# Access Compliance Report

## Public Rights-of-Way

### (Curb Ramps)

Intersection ID: 10027182	Main Street: GEMWAY_DR	Cross Street: N/A	Location: NW
ADA ID: 4B426CC4E1D7	Ramp Type: Perp	Initial Pass/Fail: Fail	Overall Compliance: No
		Severity Score: 25

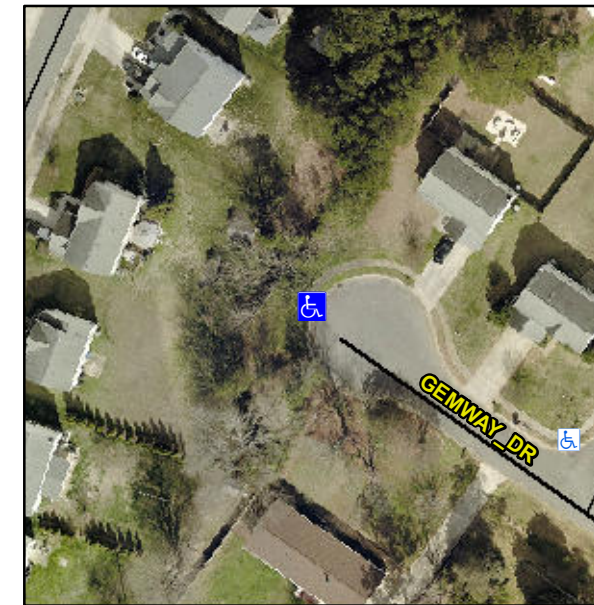
**R304.2.2**

Compliance	Description	Data	Compliance	Description	Data
N/A	Ramp Length (in)	50.0	No	Ramp Slope (%)	12.8
Yes	Ramp Width (in)	60.0	Yes	Ramp XSlope (%)	0.7
N/A	Flare Type LT	N/A	N/A	Flare Type RT	N/A
N/A	Flare Slope LT (%)	N/A	N/A	Flare Slope RT (%)	N/A
N/A	Flare Traversable LT?	N/A	N/A	Flare Traversable RT?	N/A
N/A	Landing Length (in)	N/A	N/A	DWS Provided?	N/A
N/A	Landing Width (in)	N/A	N/A	DWS Contrast?	N/A
N/A	Landing Slope (%)	N/A	N/A	DWS Length (in)	N/A
N/A	Landing X Slope (%)	N/A	N/A	DWS Full Width?	N/A
N/A	Landing Curb? (Y/N)	N/A	N/A	DWS Offset (in)	N/A
N/A	Shared Landing?	N/A			
N/A	Gutter Ponding?	N/A	N/A	Gutter Slope (%)	N/A
N/A	Gutter Lip Ht (in)	N/A	N/A	Gutter X Slope (%)	N/A
N/A	Painted X Walk1?	No	N/A	Painted X Walk2?	N/A
	X Walk 1 Direction	To SE		X Walk 2 Direction	N/A
N/A	X Walk 1 Width (in)	N/A	N/A	X Walk 2 Width (in)	N/A
	X Walk 1 Slope (%)	0.7		X Walk 2 Slope (%)	N/A
	X Walk 1 X Slope (%)	2.1		X Walk 2 X Slope (%)	N/A

**Remove & Replace Entire Ramp.**
